**ITEM #4:** For the **ARCHITECTURAL COMMISSION - 6.20.16 @ 7:00 P.M.**

**REQUEST:** Consideration of final plans including landscaping and signage for the proposed “Karen’s Corner” PUD/ Subdivision in conjunction with the petition for a SUP/PUD development as submitted by Fidelity Wes for property located at Checker Road and Old Hicks commonly known at the Iverson Property.

RE: Karen's Corner Development  
Plan/Site Review

## TYPICAL 200' LANDSCAPE PLANTING

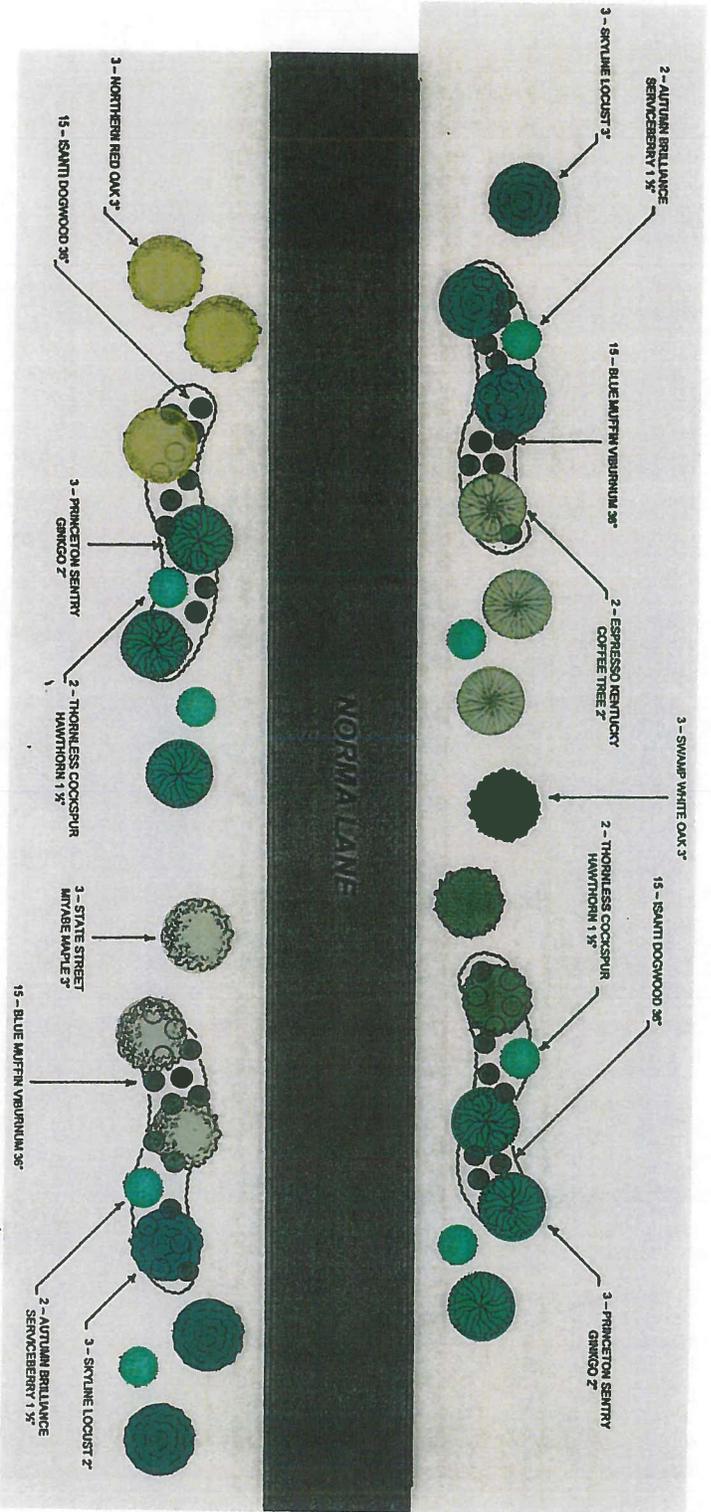
Per the review and recommendations of the Village Arborist (comments attached), plantings shown as “typical” are acceptable. Spacing requirements are suggested between trees (and ornamentals) to allow for growth. Shrubbery should not be placed within 5’ of the curb edge of the road and multi-stemmed species (such as river birch) are not recommended in the parkway due to sightline obstruction concerns.

3. The typical 200' landscape planting detail by Dowden Landscape Design, dated 5-20-16, is acceptable, but I would recommend adding more space between the shade trees and making sure there are no site obstructions with intersections, driveways, light poles, street signs, hydrants, etc. There should be a minimum of 20' - 30' between shade trees and 15' - 20' between ornamentals/evergreens and no vegetation within 15' of driveways, intersections, light poles/signs, etc. I would not allow any shrubs to be installed within 5' of the curb/edge of road.

As noted in my initial landscape plan review dated 3-21-16, I would not recommend planting multi-stemmed trees, such as river birch, in the parkway as the sightlines may be obstructed with such trees.

If the spacing that I have proposed will not allow the quantities to be installed along the parkway, I would recommend allowing these plantings to be installed in open space areas within the project or within the lots themselves, outside of utility easements and construction envelopes.

**LANDSCAPE PLAN - LANDSCAPE PLAN -**  
**ENTRANCE AREAS**

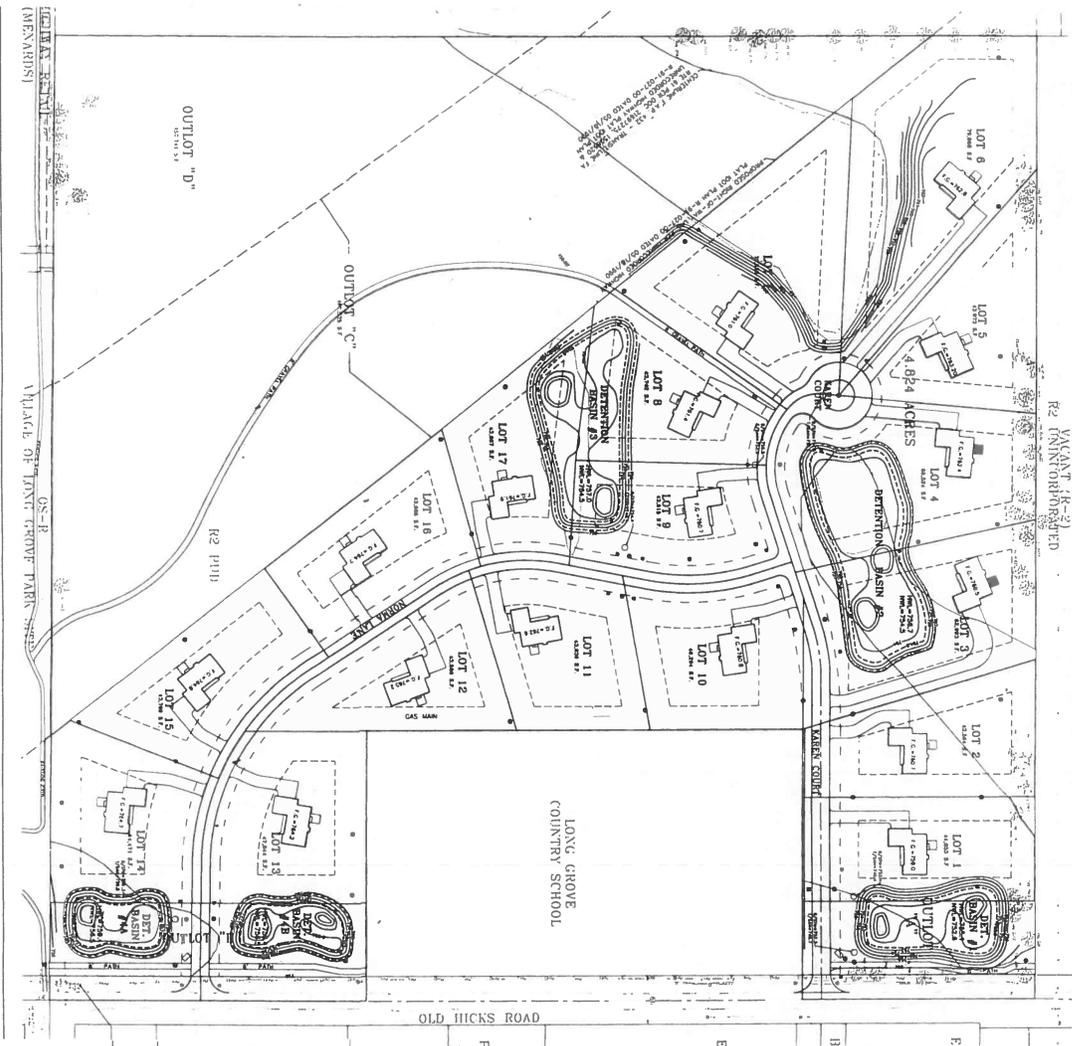
Two signs are proposed. Each would measure 5' tall by 4' wide (20 sq. ft. total) in a stacked stone façade with a limestone center. These signs would sit on a concrete base, to be landscaped, with a brick obverse. The comments of the AC (as noted at the February Meeting) have been incorporated into this proposal. Signage does not appear to be illuminated.

This signage is approvable as submitted.

The entrance signage as proposed is in conformance with Village Code and therefore approvable. Previous comments of the AC have been incorporated into the design of the sign. If the AC as any other comments regarding this signage these may be incorporated into the recommendation of the AC.
